REVISED RESPONSE TO REQUEST FOR ADDITIONAL INFORMATION

APR1400 Design Certification

Docket No. 52-046

RAI No.: 182-8160
SRP Section: 03.07.01 – Seismic Design Parameters
Application Section: 3.7.1
Date of RAI Issue: 08/31/2015

Figure 1. Comparison between APR1400 HRHF PSD, Target PSD and SRP 3.7.1 Rev. 4 CEUS rock target PSDs for H1H component

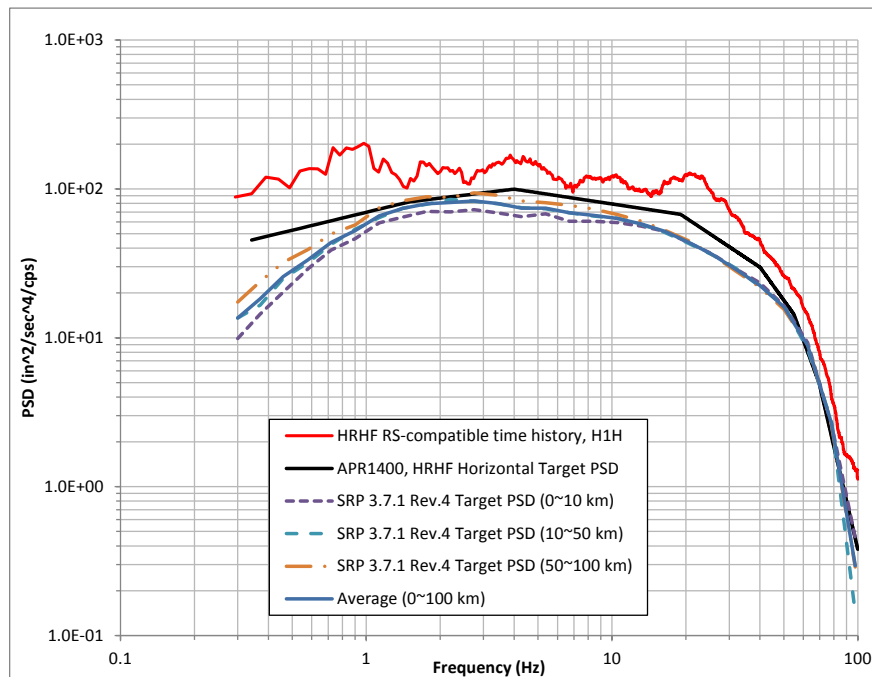
e) Upper limit of 80 Hz for HRHF Target PSD

Technical report APR1400-E-S-NR-14004-P, Rev. 1 states that the APR1400 HRHF RS-compatible target PSDs were developed in the frequency range of 0.3 Hz to 80 Hz. It is understood that 0.3 Hz is consistent with Appendices A and B of SRP 3.7.1; however, the report does not provide a basis for the choice of 80 Hz. It is recently recognized during the development of Appendix B of SRP 3.7.1 Rev. 4 that the upper bound frequency in the PSD assessment should be consistent with the DRS shape. For a DRS with a zero period acceleration (ZPA) frequency, the ZPA frequency can be used as the upper bound frequency for the development of the target PSD. However, the horizontal and vertical HRHF DRS do not exhibit a definitive ZPA (zero period acceleration) frequency. As such, the applicant is requested to justify the use of 80 Hz as the upper bound frequency for the development of target PSDs.

The comparison between the HRHF horizontal time history PSD for the H1H component and PSD given in Appendix B of SRP 3.7.1 Rev. 4 is shown in Figure 1, which shows that the APR1400 HRHF time history PSD envelope the PSD given in Appendix B of SRP 3.7.1 Rev. 4.

Figure 3-11 Smoothed Ensemble-Mean PSD and Piecewise Log-Log Linear PSD Obtained from Generated 30 Time History Ensemble

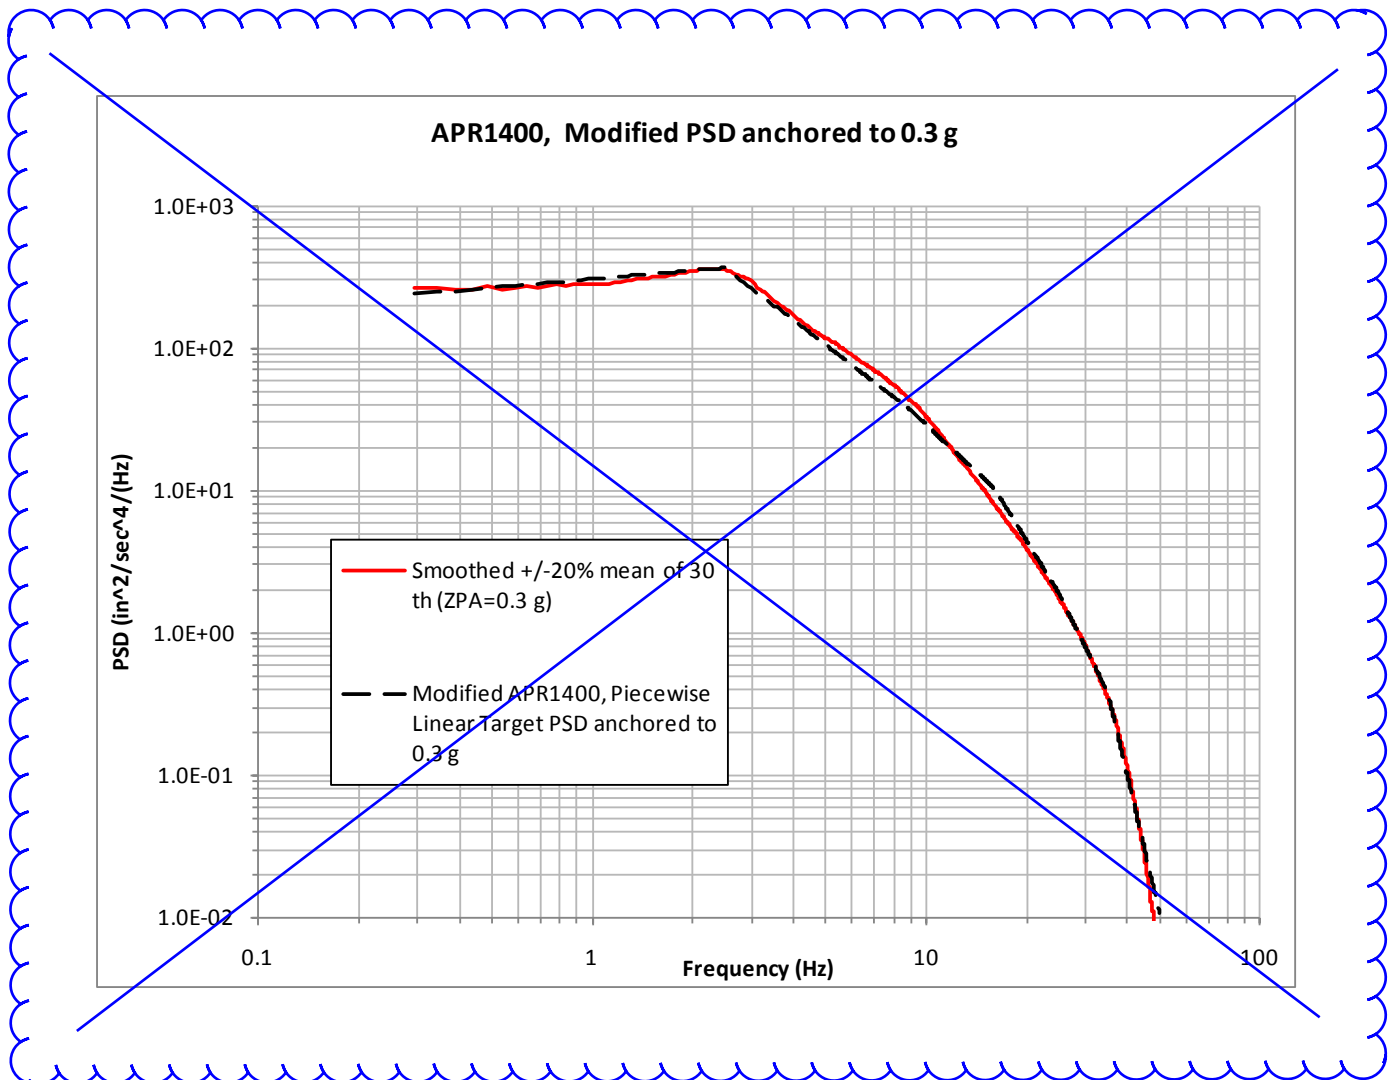
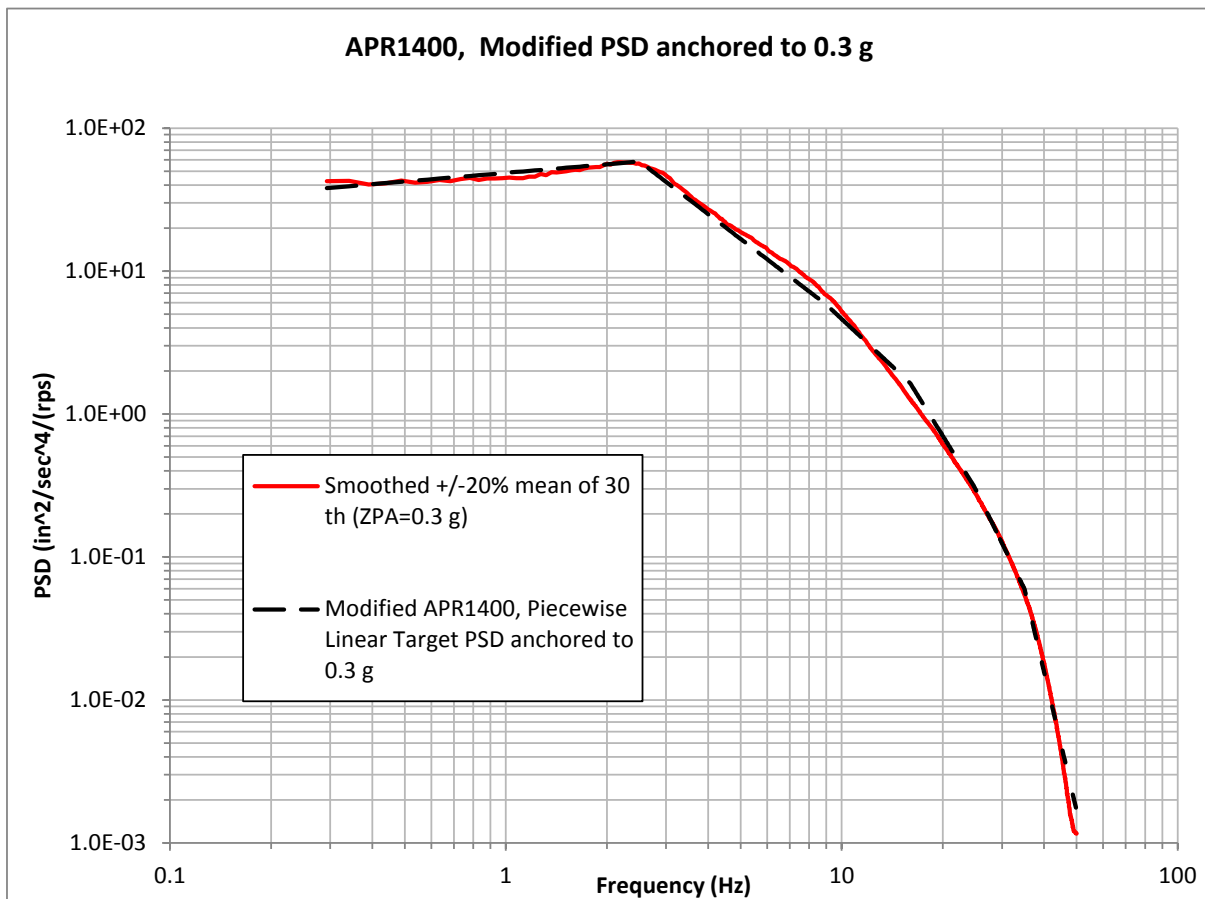
Figure 3-11 of APR1400-E-S-NR-14001-P, Rev. 0, "Seismic Design Bases" shows the smoothed ensemble-mean PSD and the piece-wise log-log linear PSD from the 30 time histories, and Figure 3-12 shows the target PSD and the minimum required PSD. Both figures are for the horizontal CSDRS anchored at 0.3 g. However, the PSD functions shown in Figure 3-11 differ significantly from Figure 3-12 (and other PSD figures after Figure 3-12). The applicant is requested to justify this difference.

- (c) The new vertical target PSD will be developed using 30 simulated time histories, and the results will be provided by June 30, 2016.
- (d) A PSD function is plotted in the unit of power (in^2/sec^4) per unit frequency. If the frequency is in Hz (cycle/sec) unit, then the PSD unit is ($\text{in}^2/\text{sec}^4/\text{Hz}$). If the frequency is in rps (radian per sec) unit, then the PSD unit is ($\text{in}^2/\text{sec}^4/\text{rps}$). Since $\omega = 2\pi f$, where f is frequency in Hz and ω is frequency in rps. Thus, the PSD value in the unit of ($\text{in}^2/\text{sec}^4/\text{Hz}$) unit is equal to 2π times the PSD value in the unit of ($\text{in}^2/\text{sec}^4/\text{rps}$), i.e., $(\text{in}^2/\text{sec}^4/\text{Hz}) = (\text{in}^2/\text{sec}^4/\text{rps}) \div 2\pi$.

The PSD in Figure 3-11 is plotted in the unit of ($\text{in}^2/\text{sec}^4/\text{Hz}$). The PSD in Figure 3-12 (and other PSD figures after Figure 3-12) is plotted in the unit of ($\text{in}^2/\text{sec}^4/\text{rps}$). The PSD in Figure 3-12 multiplied by a factor of 2π will give the numerical value of the PSD in the same unit of PSD in Figure 3-11. The use of the unit of ($\text{in}^2/\text{sec}^4/\text{Hz}$) is convenient for comparison with the target PSD compatible with the target PSD for the RG 1.60 horizontal spectra. The use of the unit of ($\text{in}^2/\text{sec}^4/\text{rps}$) is convenient for checking compatibility with the time history PSD, which is computed from the Fourier spectrum in the frequency unit of rps.

Figure 3-11 of technical report APR1400-E-S-NR-14001-P/NP, Rev. 0 will be revised.
